# Technical Service Bulletin (TSB)

**Right or Left Front Speaker Rattle with McIntosh System**

REFERENCE:	<b>TSB:</b> 23-023-23 REV. A <b>GROUP</b> 23 - Body	Date:	May 4, 2023	REVISION:	23-023-23
VEHICLES AFFECTED:	This bulletin applies to vehicles bu (MDH 1018XX) equipped with the 19 Speaker System (Sales Code RCA)	023 (WS) Grand Wagoneer/Wagoneer letin applies to vehicles built on or before October 18, 2022 018XX) equipped with the 19 Speaker McIntosh <sup>®</sup> Audio System (Sales Code RCA) or 23 Speaker McIntosh Reference peaker Systems (Sales Code RGE).		⊠NA	PPLICABILITY: MEA IAP CH
CUSTOMER SYMPTOM:	The customer may describe speaker rattle heard during any audio play from the right or left front speakers specifically.				
CAUSE:	Possible source of noise could be the McIntosh <sup>®</sup> Badge on speaker grille.

Fig. 2 Tape Properly Installed

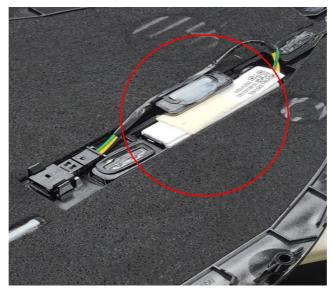
5. Light should now be secured to the tape and speaker grille (Fig. 2) .
